Rutland City BRF 3000 (2014036)
SUBMITTAL 75.1

Topic	900.645 Prefabricated Bridge Truss - Response to Review Comments
Status	For Approval
Spec section	900.645
Responsibility	(19) Ripley Road
Sent to approver	12/3/15
Required from approver	12/10/15

Attachment: Sheet T21

CABLE PEDESTRAL BARRIER DETAILS	PROJECT NAME: RUTLAND CITY	PLOT DATE: 8/14/2015
	PROJECT NUMBER: BRF 3000 (19)	DRAWN BY: B. LAVERGNE
	FILE NAME: _____	CHECKED BY: M. BRASSARD
	PROJECT LEADER: T. DENSFORD DESIGNED BY: T. DENSFORD DWG. NO.:	SHEET T21 OF

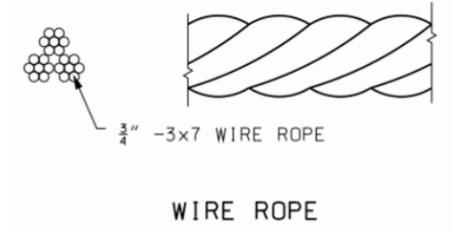
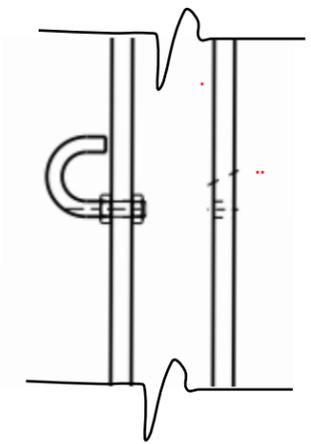
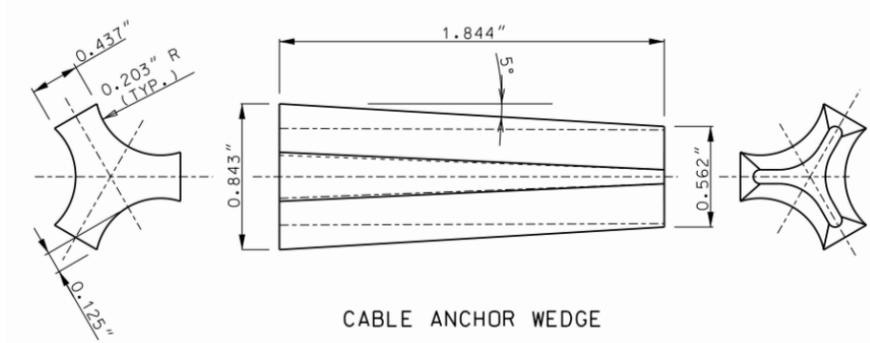
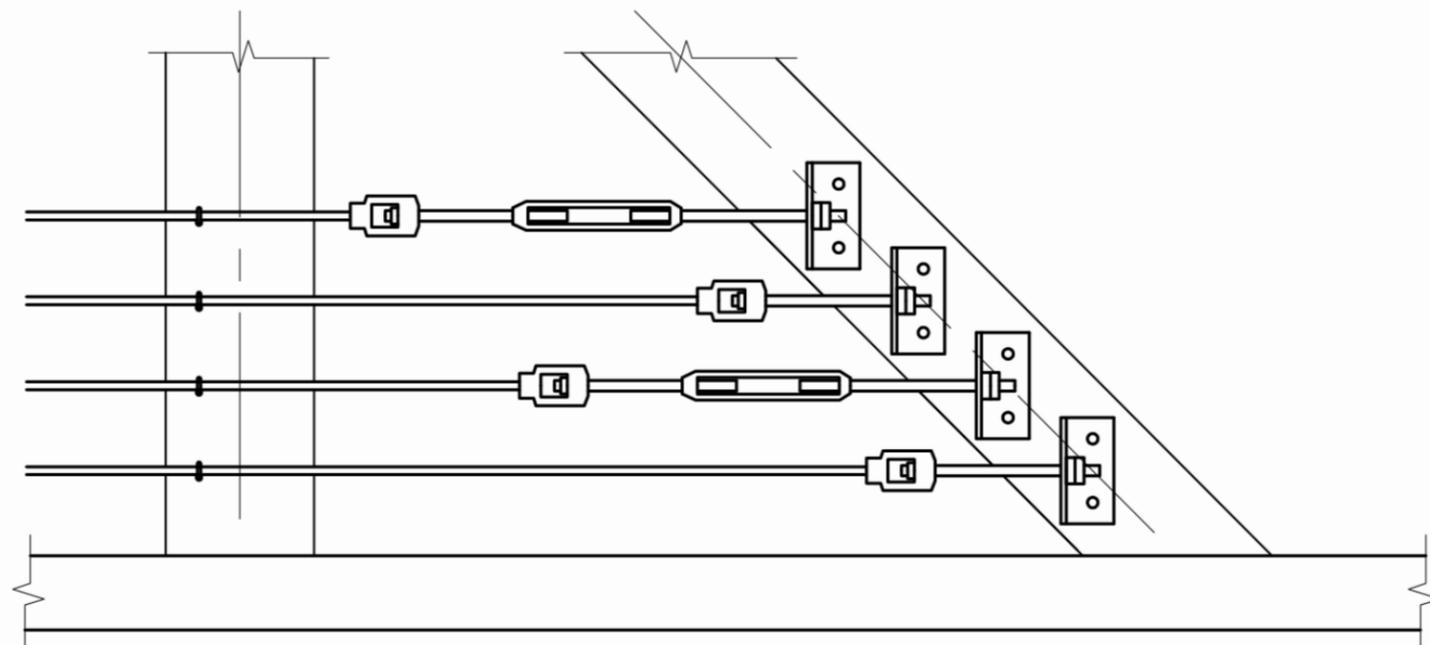
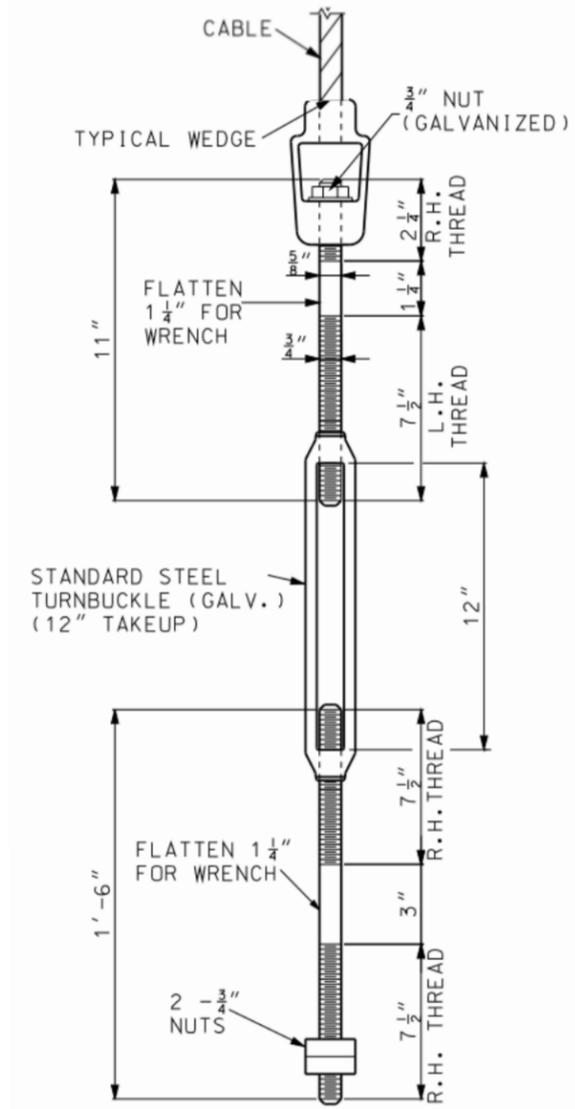
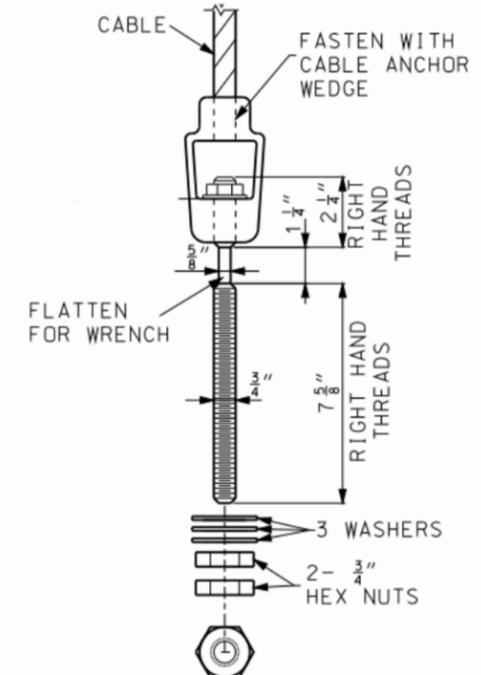
2. A cable rail system pedestrian barrier shall be detailed with applicable VTrans and AASHTO guidelines as shown on the Typical Section on Sheet 64 of 245, to be paid for under the Truss pay item. It appears that the only mention in this submittal is on the Typical Bridge Section, sheet T3, which says "Pedestrian Barrier Per Std. Spec." Please provide details for this barrier.

Response 2: General details for the cable pedestrian barrier are attached on sheet T21. We do not find cable rail design requirements in the special provisions, standard specifications, and contract plans to detail the cable rail. Contract plan sheet 64 shows the cable rail and references VTrans and AASHTO guidelines. AASHTO LRFD 13.8.1 requires railings to be 42" tall, with 6" clear openings. Sheet 64 shows four cables, which would not meet the 42"/6" requirement, so we are unclear as to the intent. Please review and comment on the attached drawing, and provide desired dimensions, or confirm that 42"/6" is sufficient.

- NOTES:
1. CABLE GUARDRAIL SHALL MEET SECTIONS 621 AND 713.03 OF THE STANDARD SPECIFICATIONS.
 2. VTRANS IS REQUESTED TO FURNISH SPACING, NUMBER, AND HEIGHT OF CABLE GUARDRAIL CABLES.
